July 13, 2018

RE: Response to Notice of Violation Issued to Advanced Disposal Services Eagle Point Landfill
Permit No. 058-012D, Forsyth County

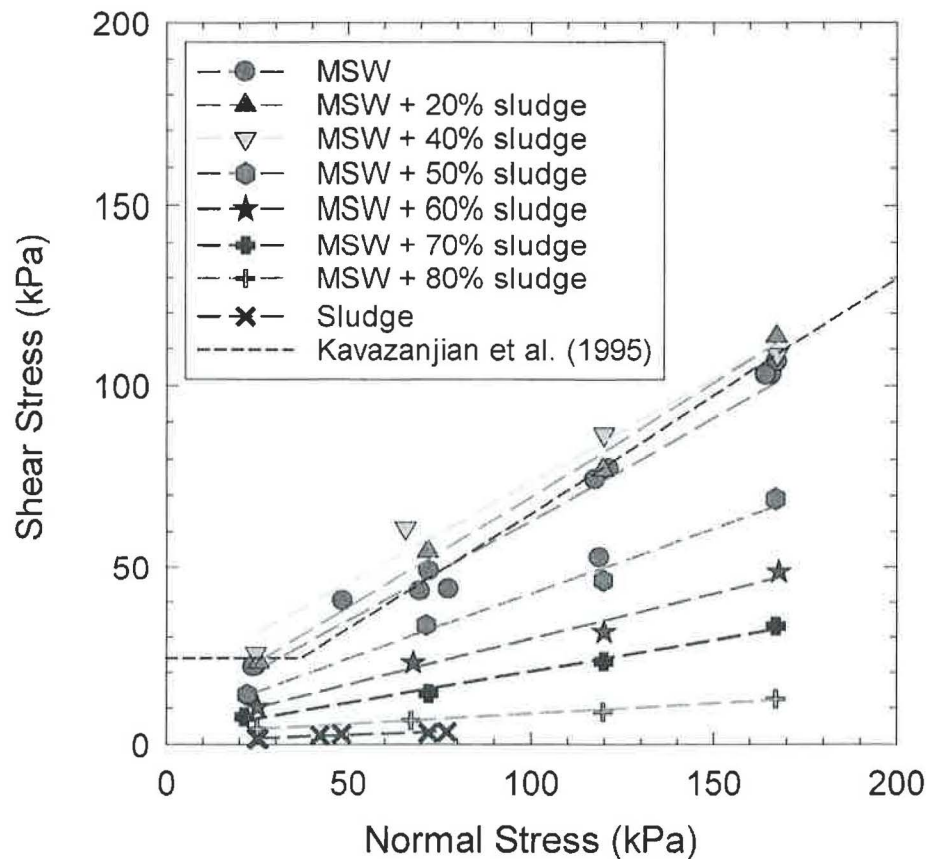
Invalid Study - The slope stability issues happened

The data in the figure indicates that the MSW without LSSW has comparable strength as the generalized recommendation for strength of MSW in Kavazanjian et al. (1995). The test results also show that the strength is unaffected by LSSW content until the LSSW content exceeds 40%. At ratios exceeding 40%, the strength decreases (slope of the envelope, or ϕ' , decreases) as the LSSW content increases.
